EAGLE MOUNTAIN PLANNING COMMISSION MEETING

May 12, 2020, 5:30 PM

EAGLE MOUNTAIN CITY
PLANNING COMMISSION MEETING
MAY 12, 2020

TITLE:	Auto Zone Site Plan & Recorded Plat Amendment - Public Hearing
ITEM TYPE:	Recorded Plat Amendment & Site Plan
APPLICANT:	Colby Anderson

C1.1

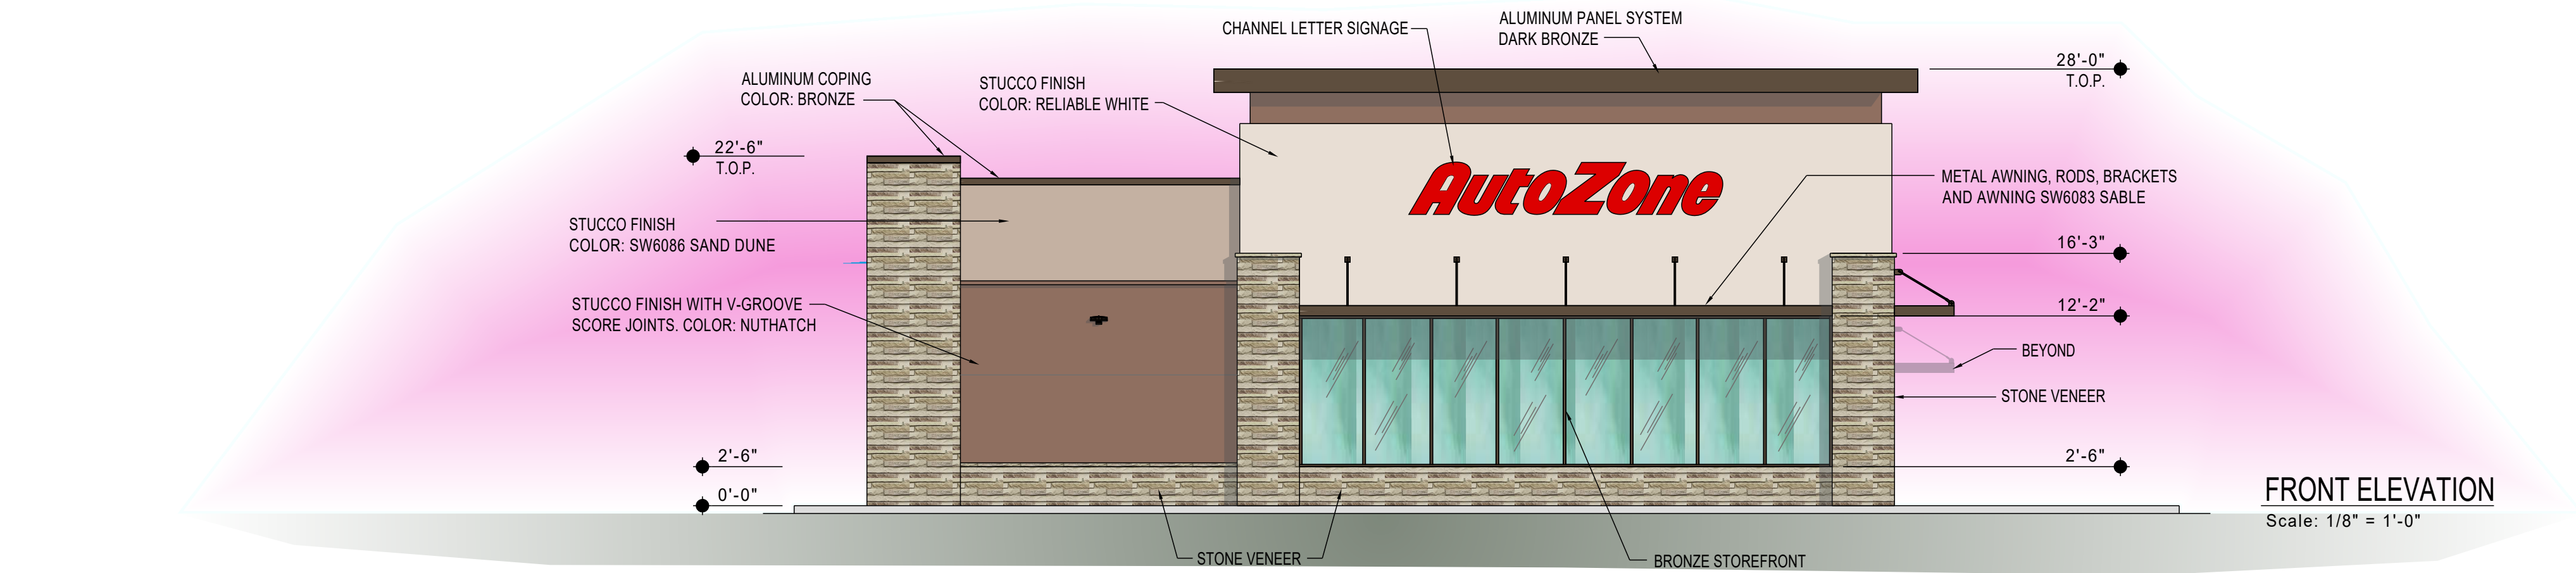
This an application for a Recorded Plat Amendment and proposed Site Plan for an Auto Zone supply store located on lot 7 in the Porter's Crossing Town Center along Pony Express Pkwy. The lot is 2.39 acres with a majority of the lot in the Tickville Wash. As a part of this project the applicant is doing a recorded plat amendment to remove the Tickville Wash portion from Lot 7, creating a separate lot for the Tickville Wash.

1. The applicant moves the building forward to the front of lot 7 to comply with the City's Commercial design standards.
2. The parking currently located in the front of the building is moved or remove form the site.

1. The applicant moves the building to the front of the lot along Pony Express Pkwy.
2. The applicant moves or removes the parking in the front of the building.
3. A lighting plan is submitted that complies with the dark sky lighting ordinance.
4. Any conditions that the Planning Commission deems appropriate.

CE-1

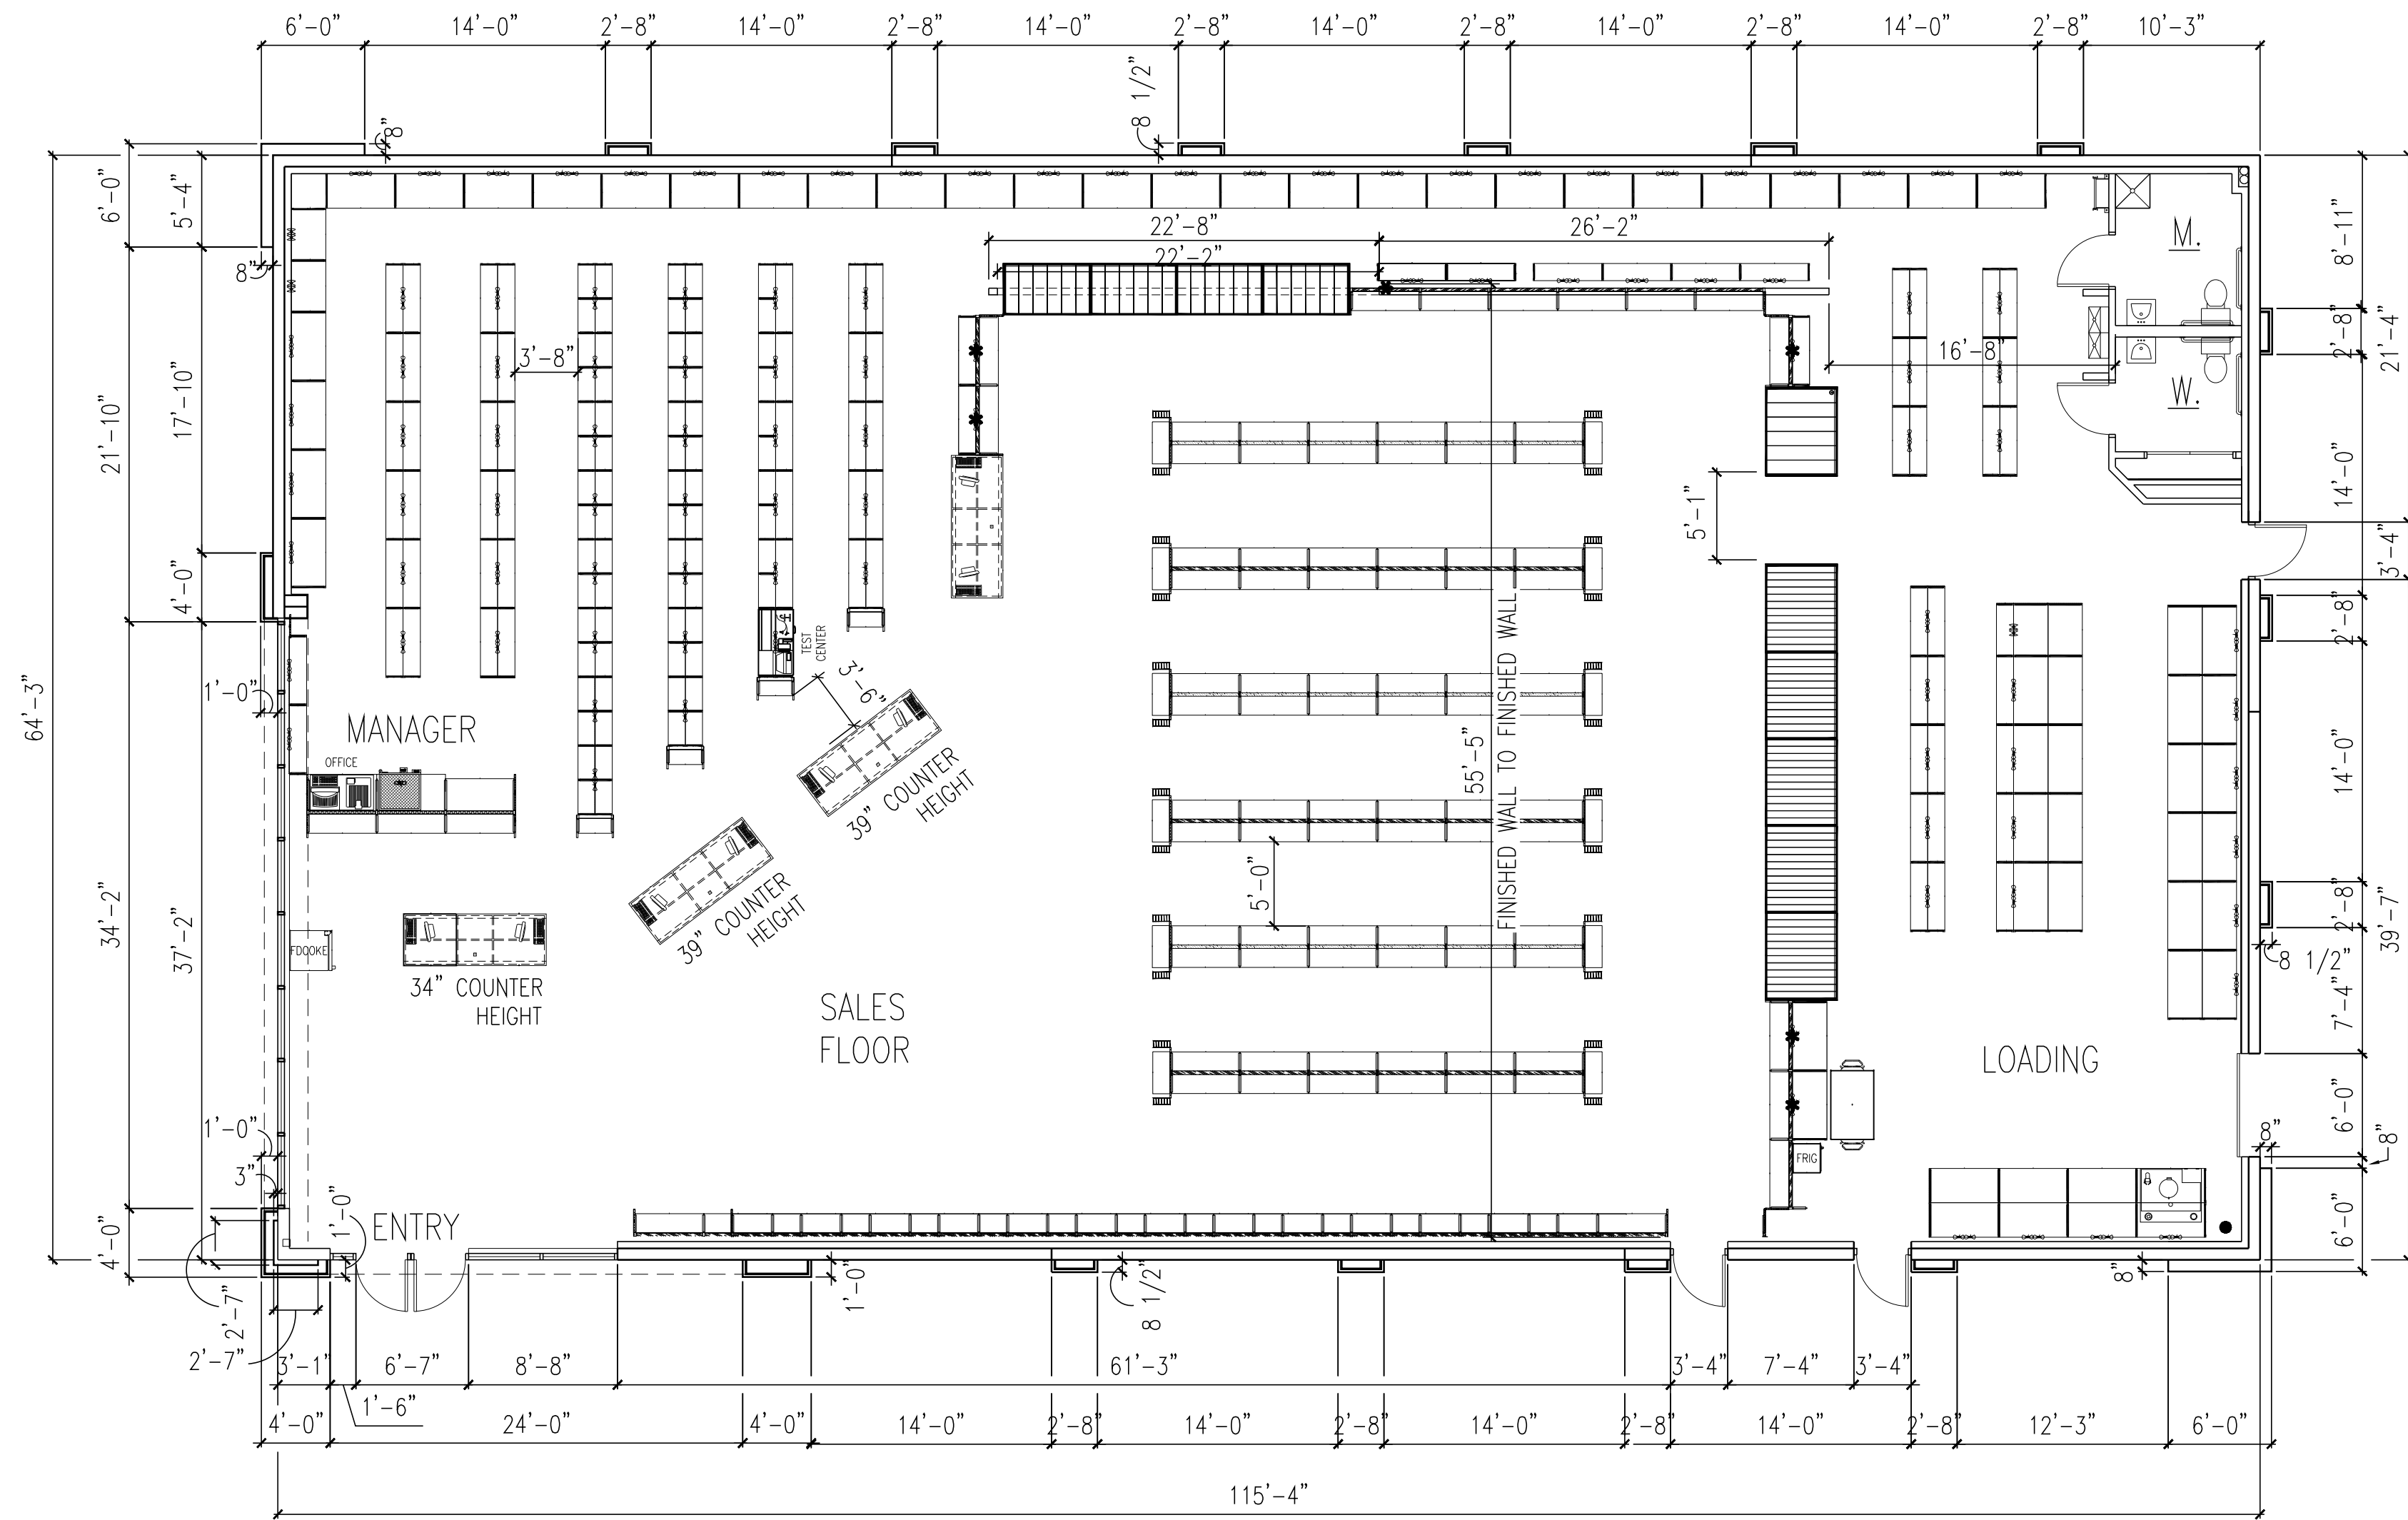
It is up to the Planning Commission and City Council to determine if the materials and colors of the Auto Zone are similar to the neighboring structures in the development. Minor deviations from these elevations, still in compliance with the Design Standards, require approval by the Planning Director.

SHEET:
C-1
DATE: Apr 30, 2020

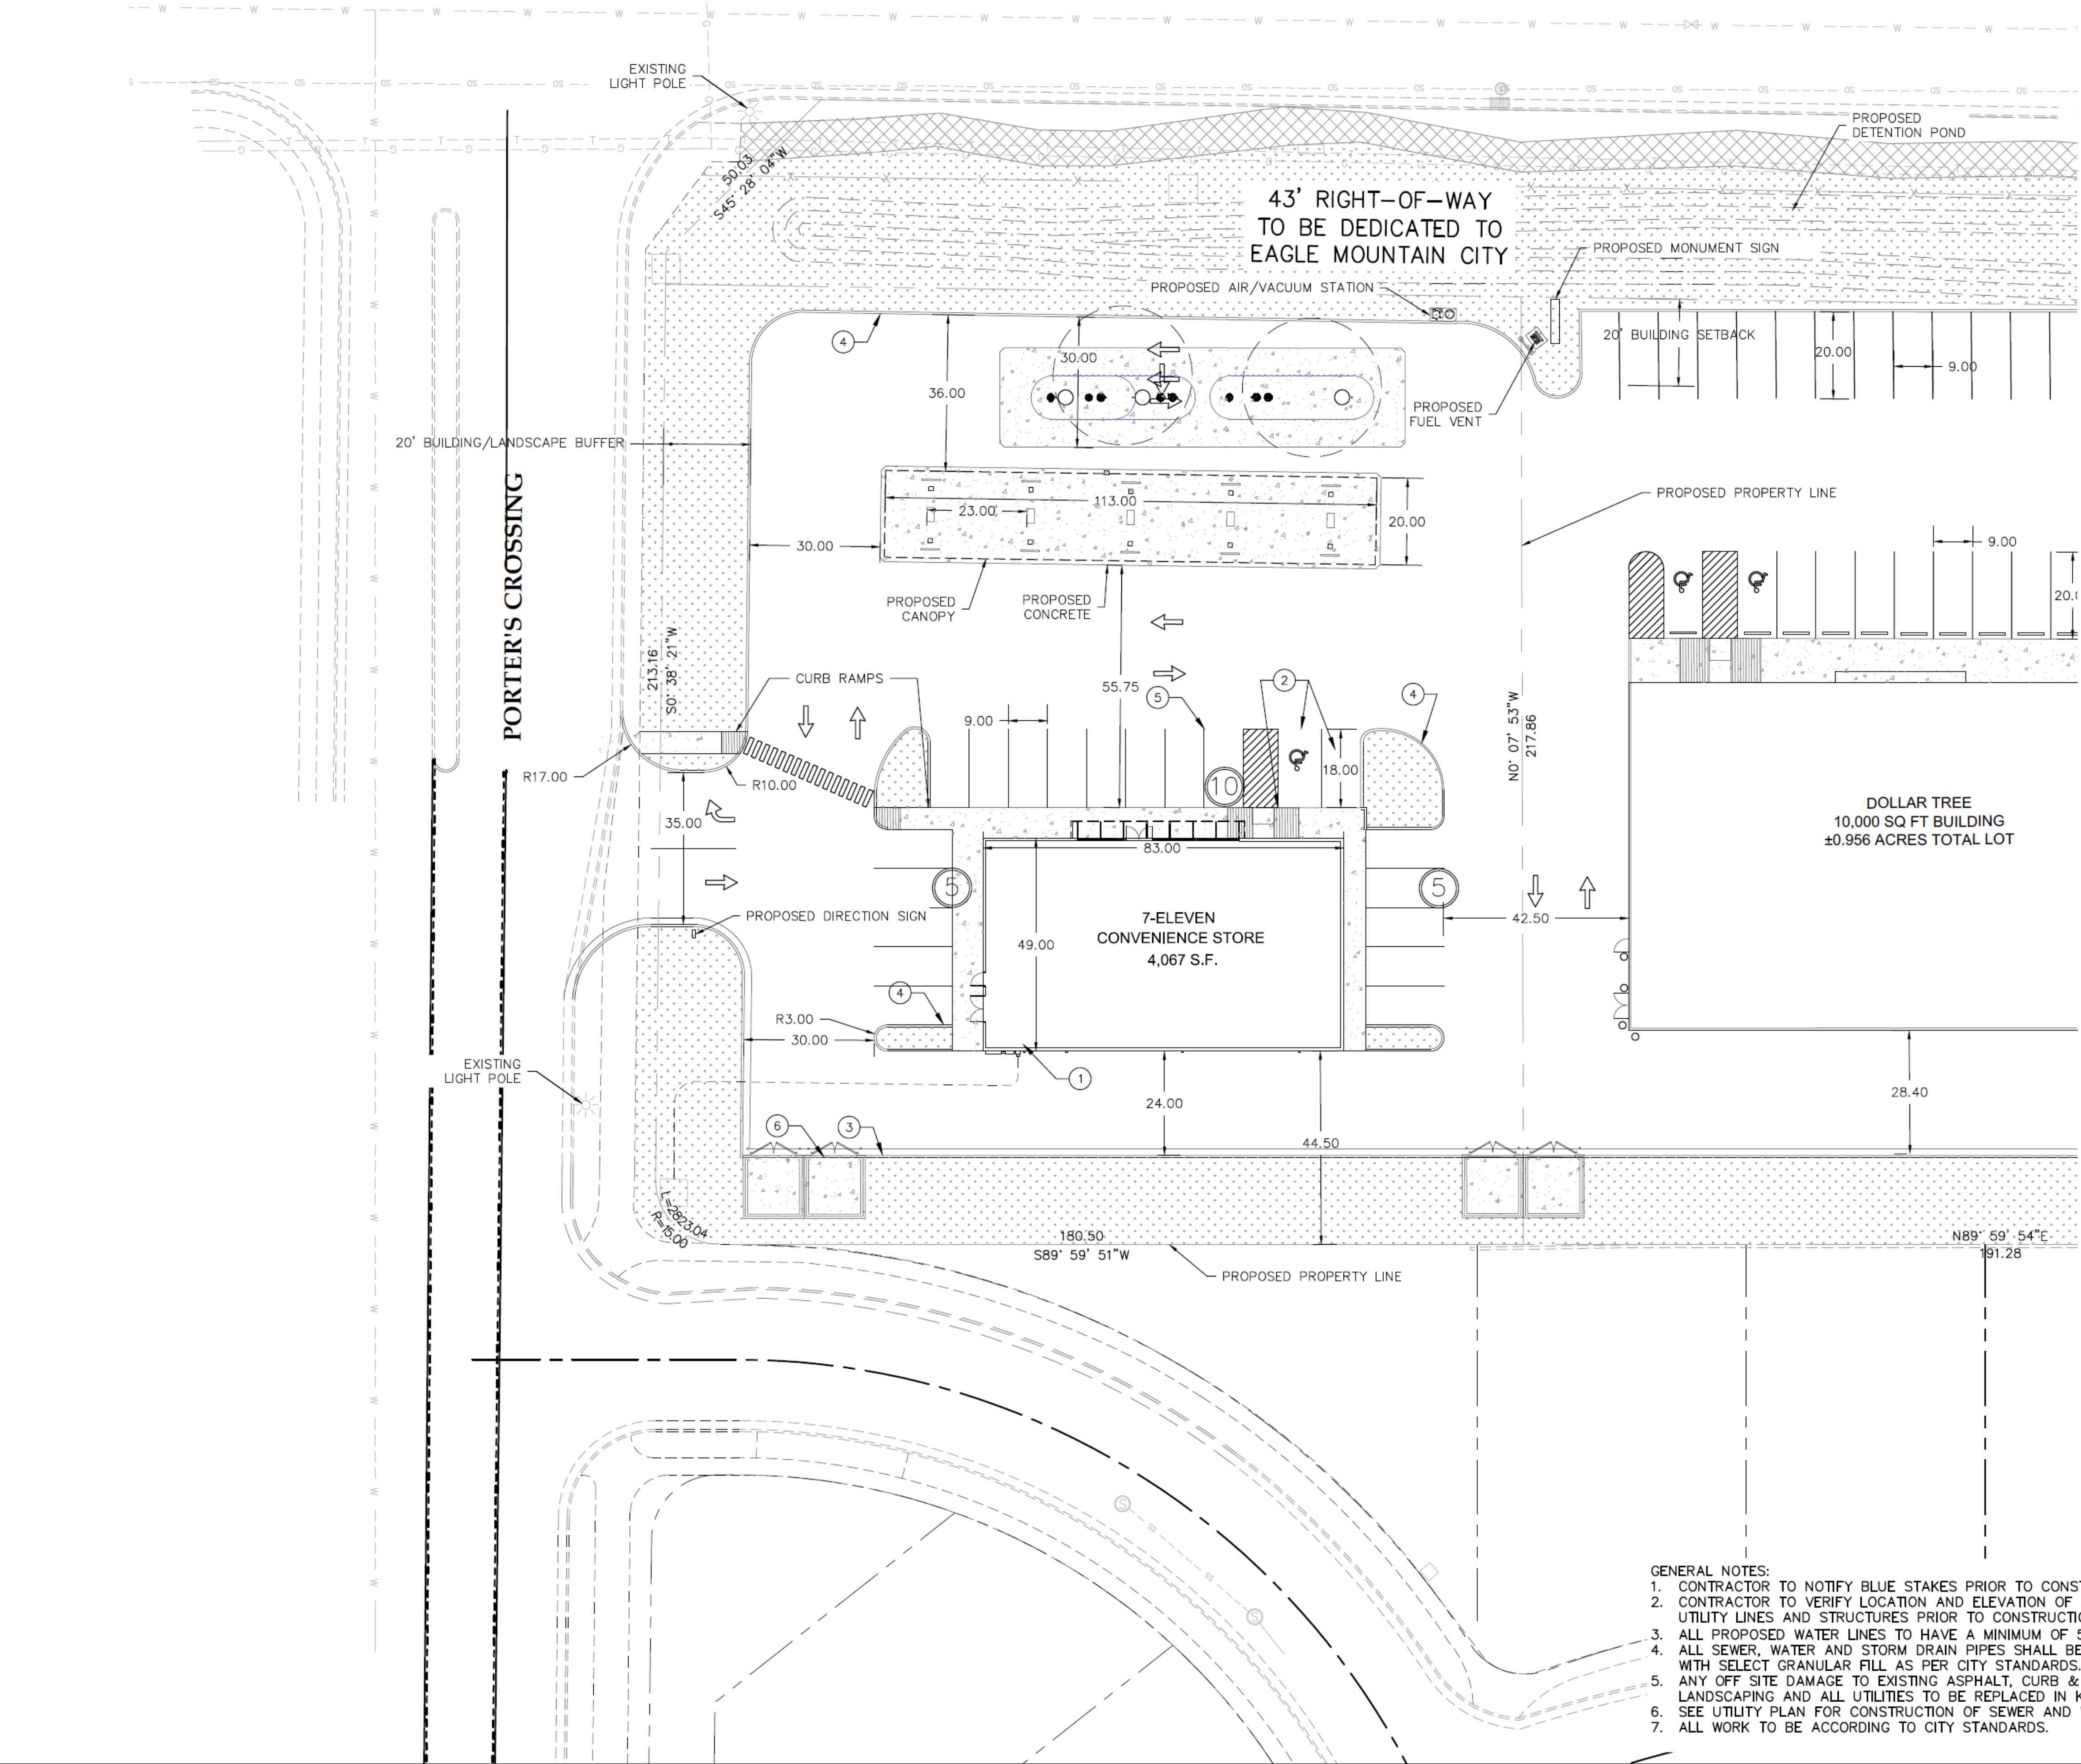
This application is for a Site Plan located in Carson Commercial development Lot 1 – approximately 2.0 ac in size. The Carson Commercial Master Site plan development was approved by the City Council on August 6 2019. This proposed project is for a 7-11 convenience store. This application is being proposed along with the Dollar Tree site plan application. Both site plans are proposed on Lot 1 of Carson Commercial. The 2 acre lot has enough acreage for both site plans. The applicant is interested in dividing the 2 acre lot into 1 acre lots. The agreement between the land owner and the applicant requires that any modification of the Carson Commercial Lot 1 will require the applicant to pay for any fees associated with the modification of the lot. Since the Carson Commercial plat 3 has not yet been recorded the dividing of lot 1 could be processed as a final plat. It will be up to the Planning Commission and City Council to decide if the applicant can work with staff on a final plat application.

1. All landscaping to be improved up to Pony Express Pkwy with a mixture of plants and rock.
2. The signage shall comply with city code requirements.
3. All lighting shall comply with the dark sky lighting ordinance.
4. Any conditions that the Planning Commission deems appropriate.
